FOREST LAKES  
PHASE 2

Major Amendment  
PUDSP -all sheets

PUDSP-18-001

DEVELOPMENT PLAN AND  
CONCEPTUAL SITE PLAN FOR PHASE 2

PRELIMINARY GRADING & UTILITIES PLAN

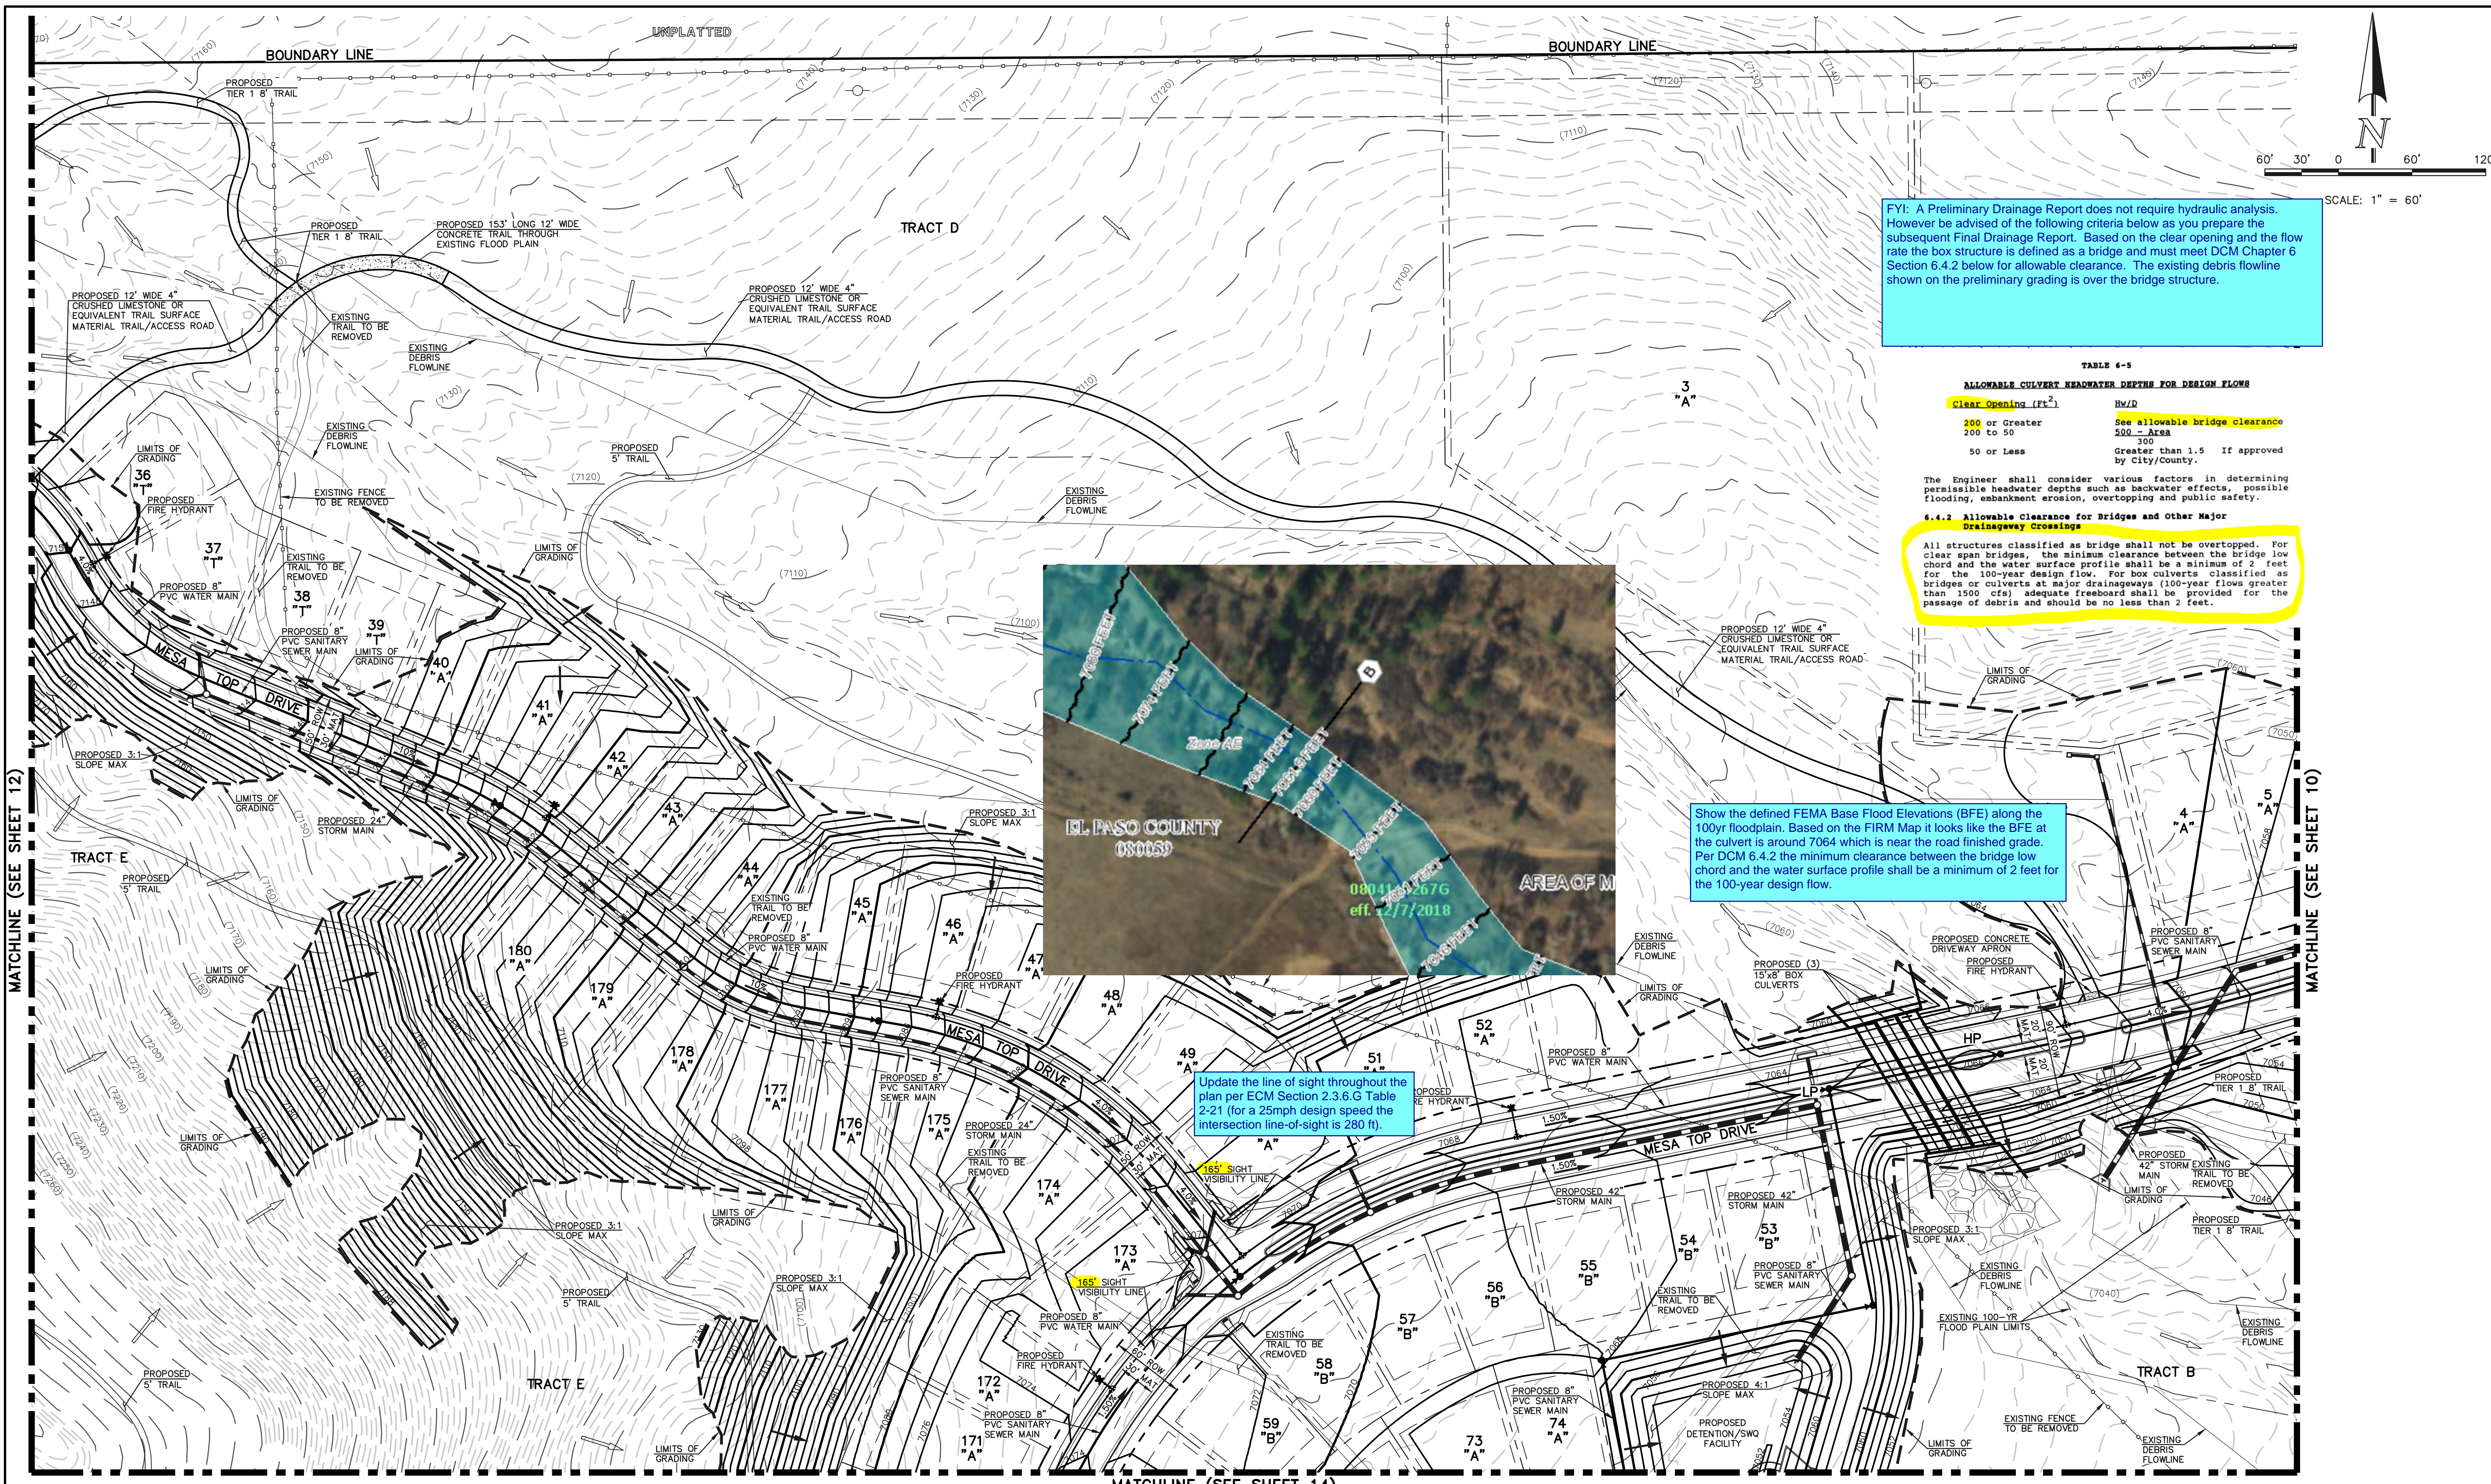
**FYI: A Preliminary Drainage Report does not require hydraulic analysis. However be advised of the following criteria below as you prepare the subsequent Final Drainage Report. Based on the clear opening and the flow rate the box structure is defined as a bridge and must meet DCM Chapter 6 Section 6.4.2 below for allowable clearance. The existing debris flowline shown on the preliminary grading is over the bridge structure.**

Show the defined FEMA Base Flood Elevations (BFE) along the 100yr floodplain. Based on the FIRM Map it looks like the BFE at the culvert is around 7064 which is near the road finished grade. Per DCM 6.4.2 the minimum clearance between the bridge low chord and the water surface profile shall be a minimum of 2 feet for the 100-year design flow.

Update the line of sight throughout the plan per ECM Section 2.3.6.G Table 2-21 (for a 25mph design speed the intersection line-of-sight is 280 ft).

**90' R.O.W. TYPICAL STREET URBAN LOCAL ROADWAY**  
SCALE 1" = 1'

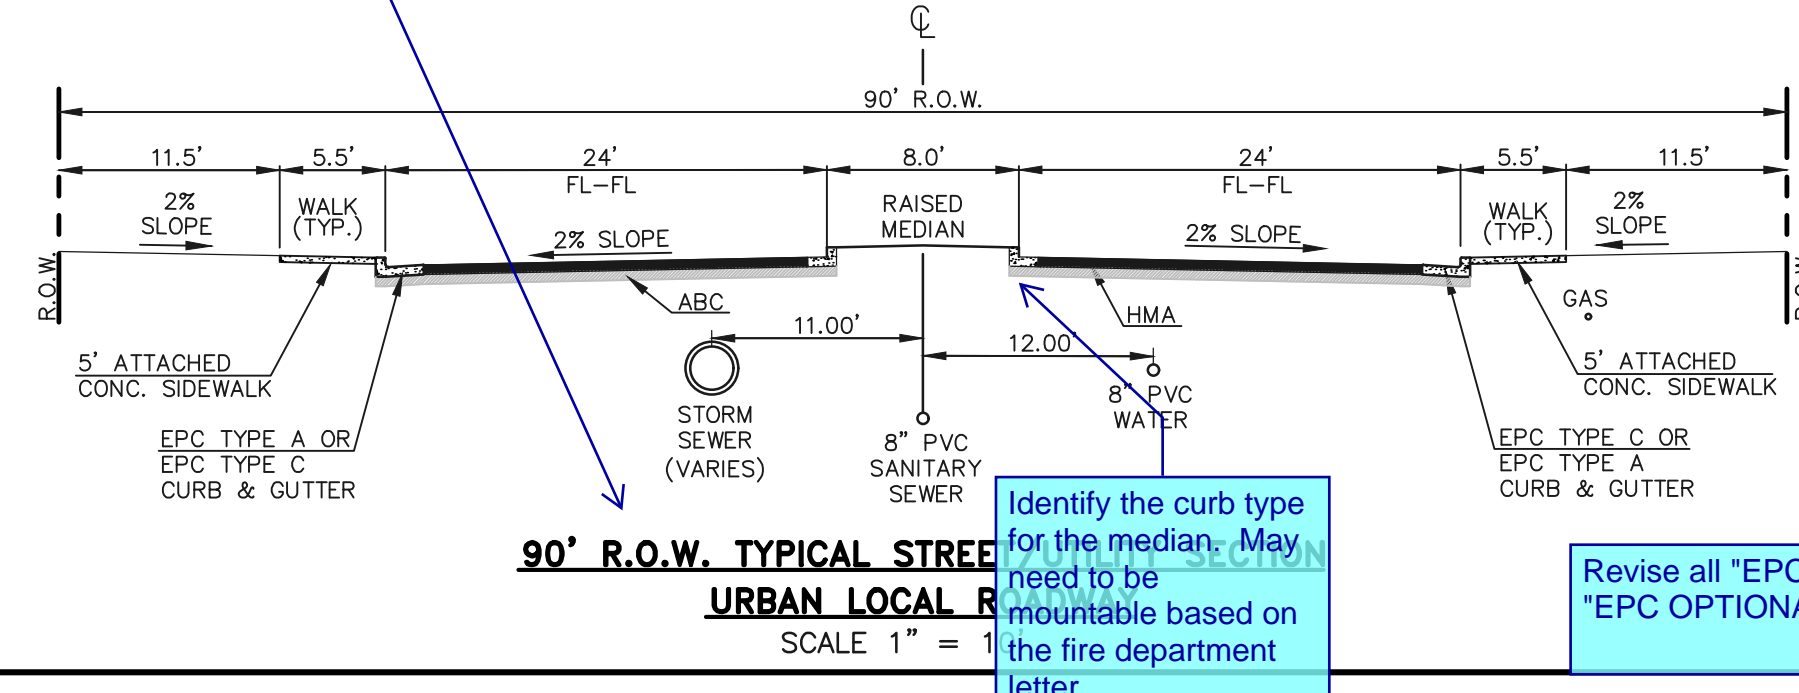
Parking is permitted on urban local roads. Based on the Fire Department letter the roadway must be widened by an additional 9 feet on both sides to allow fire apparatus to flow freely alongside parked cars.

List the applicable streets associated with each cross sections.  
Is the raised median landscaped? If so a landscape agreement is required.  
Show the 5' public improvement easement on both sides of the right-of-way on all the typical street sections.

**60' R.O.W. TYPICAL STREET/UTILITY SECTION URBAN LOCAL ROADWAY**  
SCALE 1" = 10'

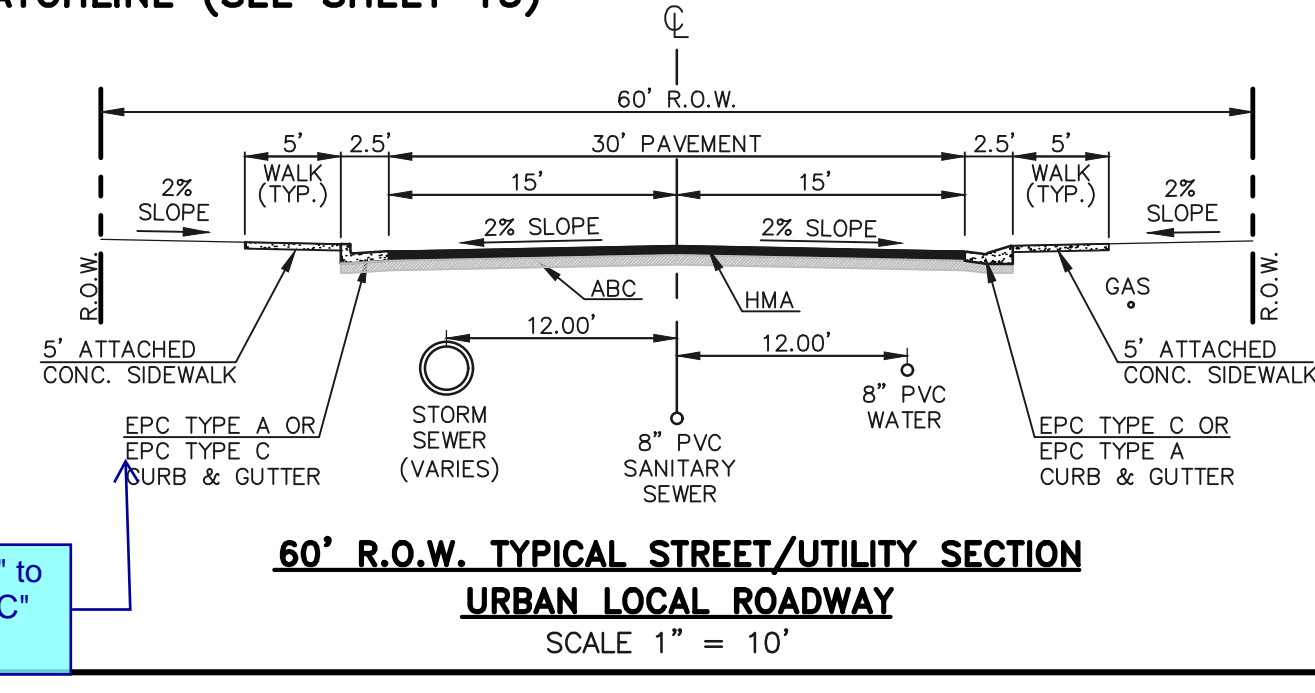
Identify the curb type for the median. May need to be mountable based on the fire department letter.

**50' R.O.W. TYPICAL STREET/UTILITY SECTION URBAN LOCAL ROADWAY**  
SCALE 1" = 10'

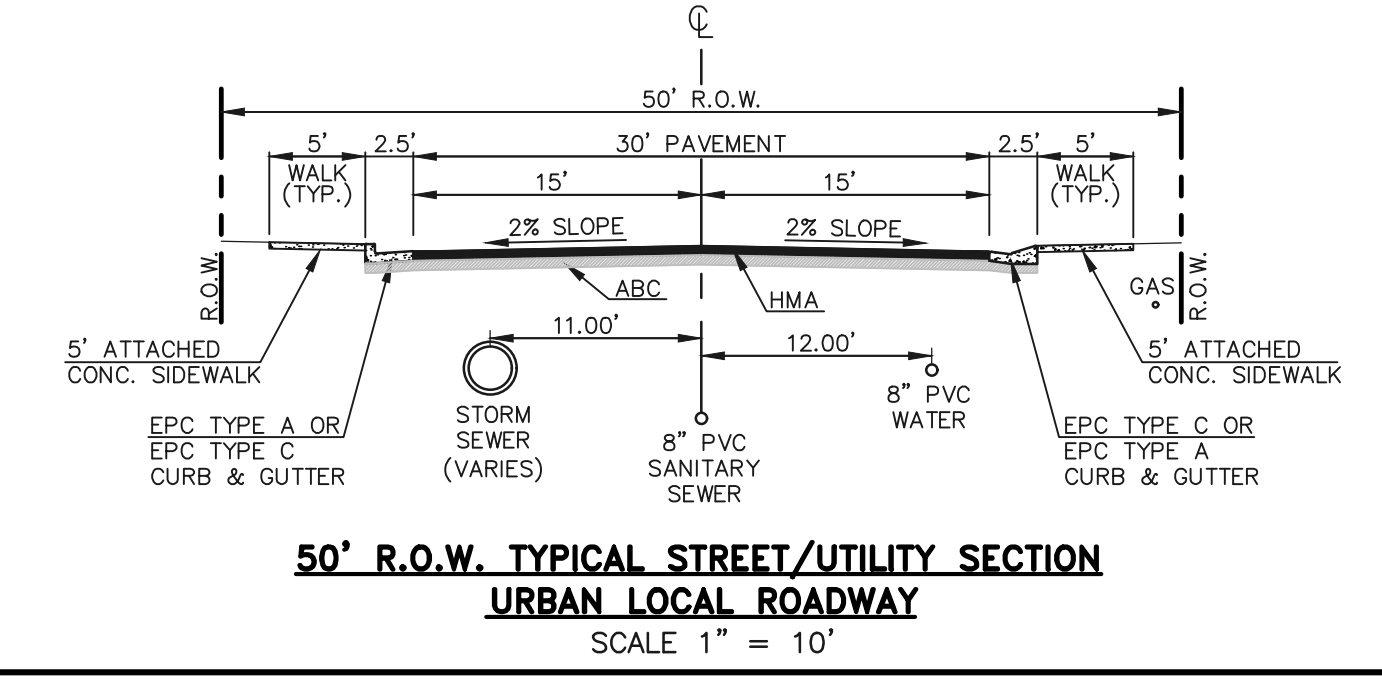
Revise all "EPC TYPE C" to "EPC OPTIONAL TYPE C"

PRELIMINARY GRADING & UTILITIES PLAN

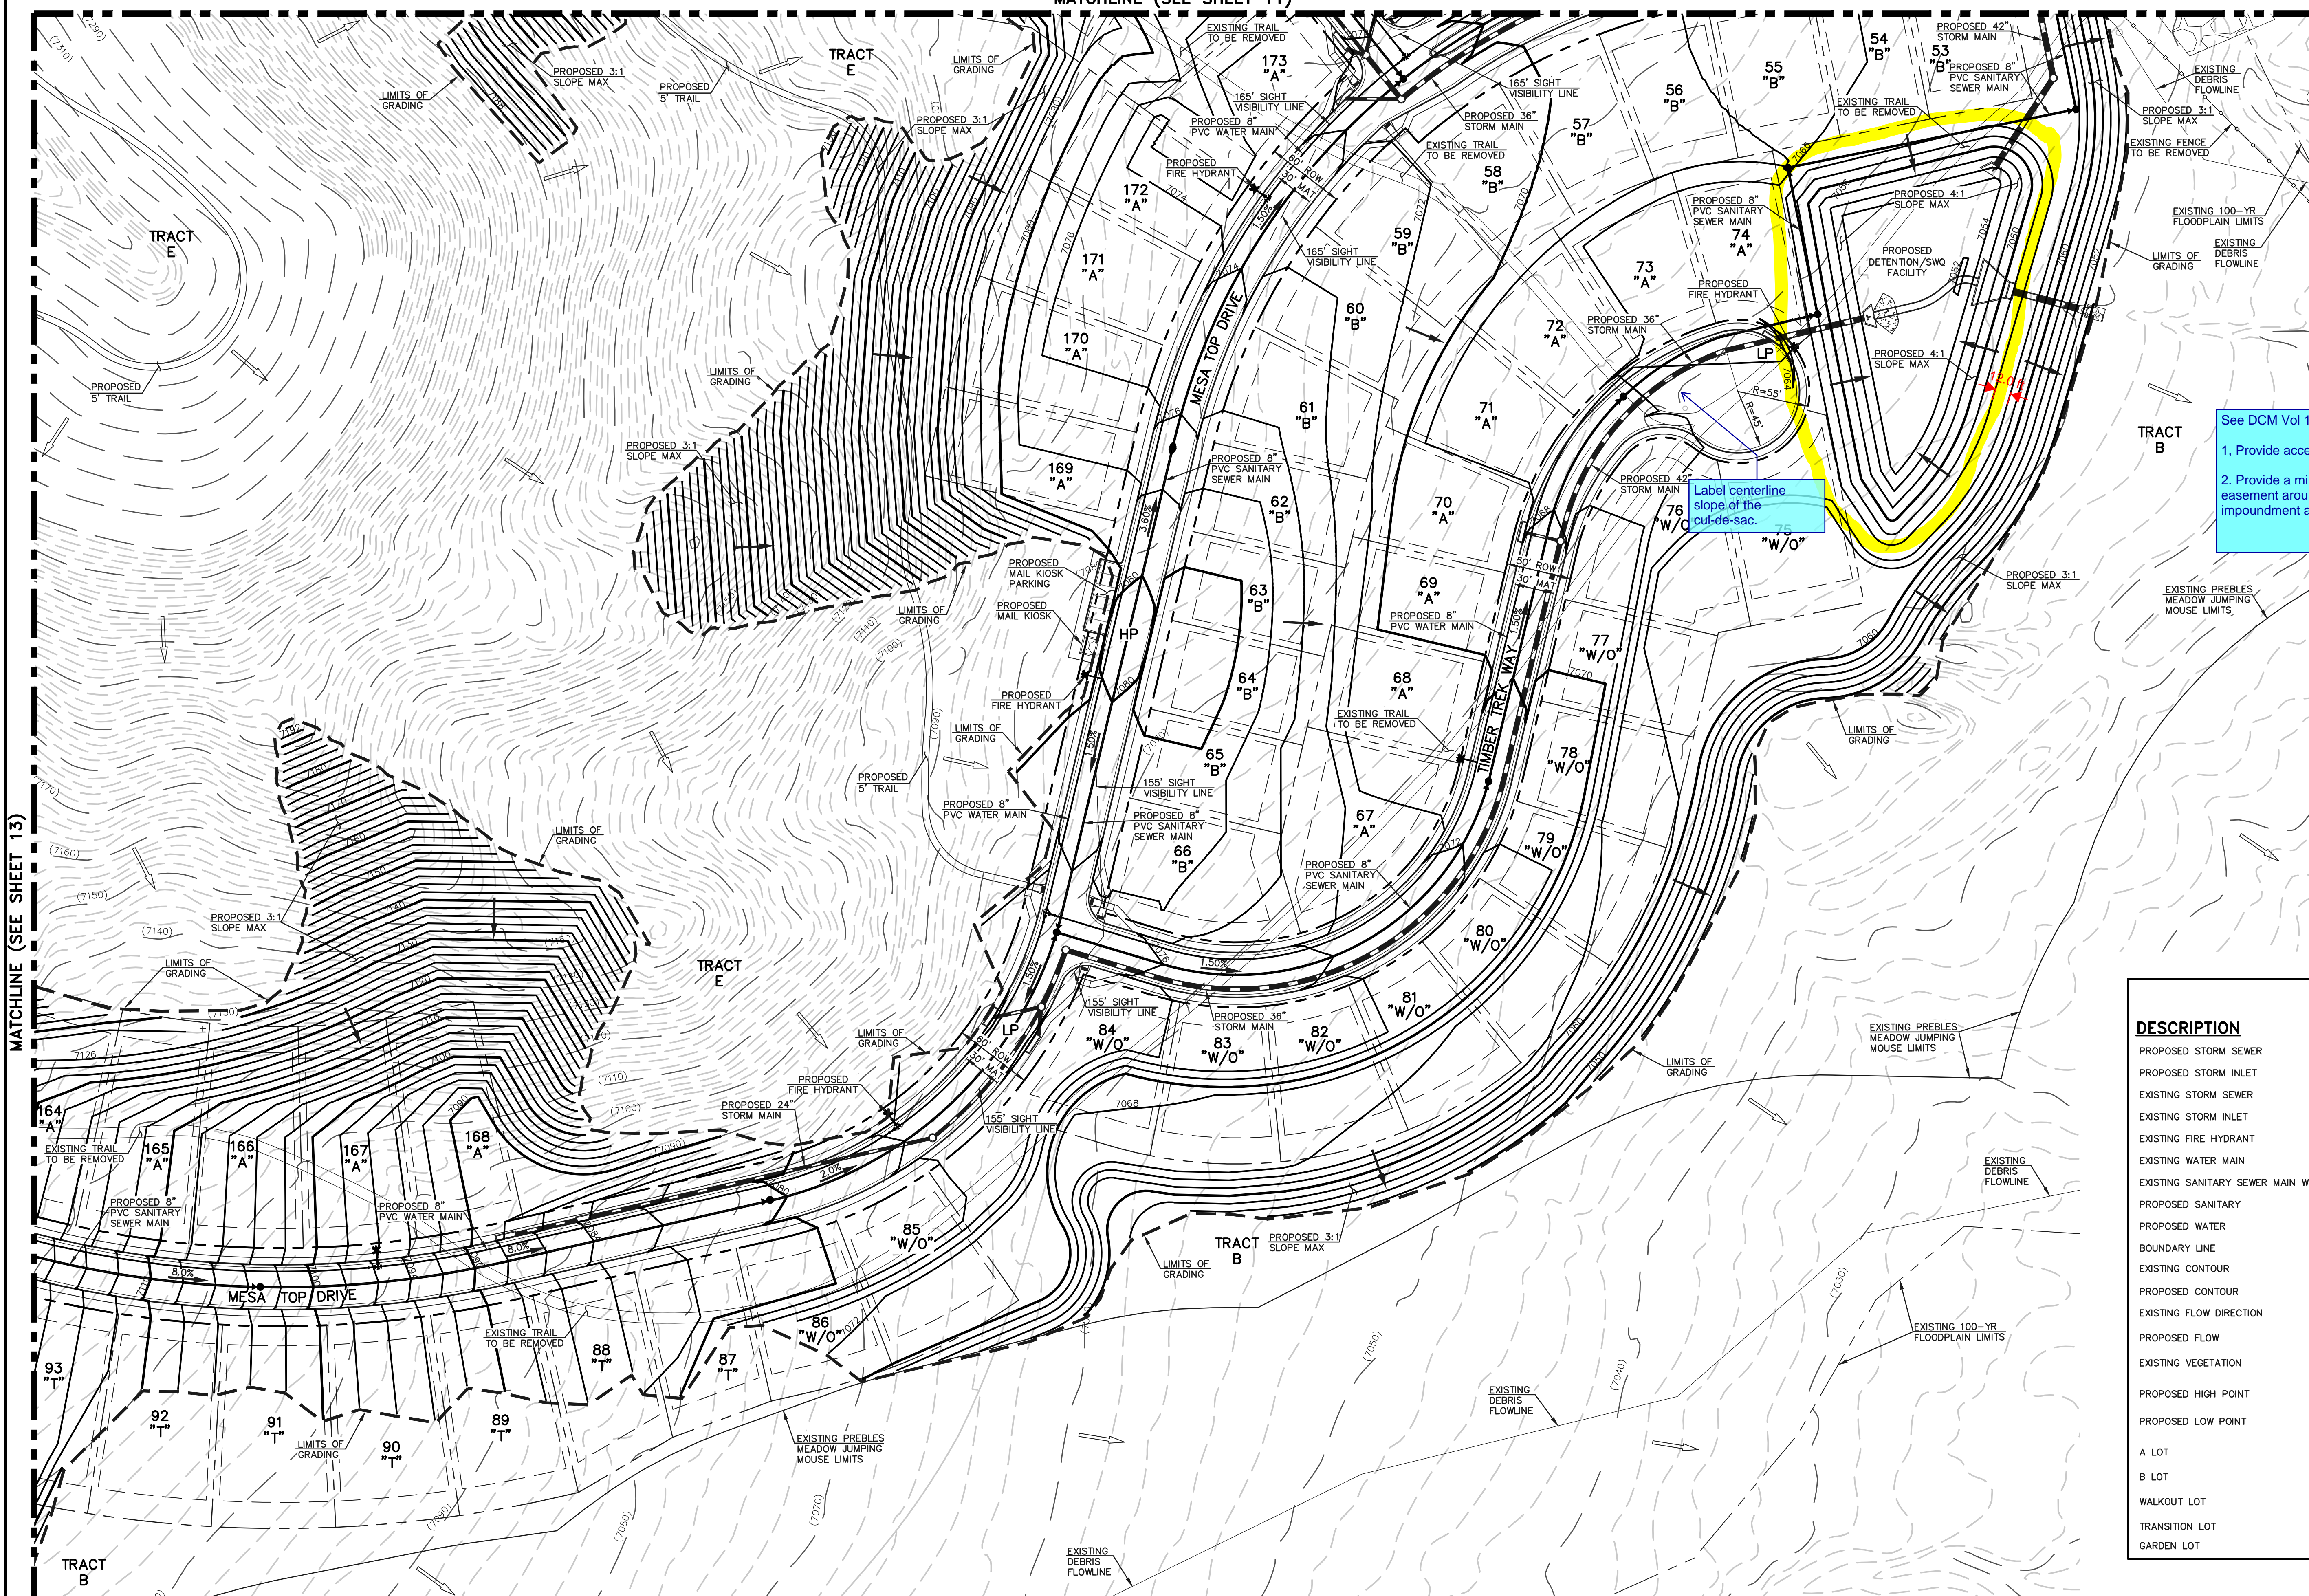
Identify the overflow path for each inlet located in a low point. Additional easements across the downstream lots may be required.

Driveway for pond maintenance access is in conflict with the storm inlet.

- See DCM Vol 1 Section 11.2.2
1. Provide access ramp to the bottom of pond.
  2. Provide a minimum 15' maintenance easement around the perimeter of the impoundment area.

See DCM Vol 1 Section 11.2.2

1. Provide access ramp to the bottom of pond.
2. Provide a minimum 15' maintenance easement around the perimeter of the impoundment area.

Label centerline slope of the cut-de-sac.
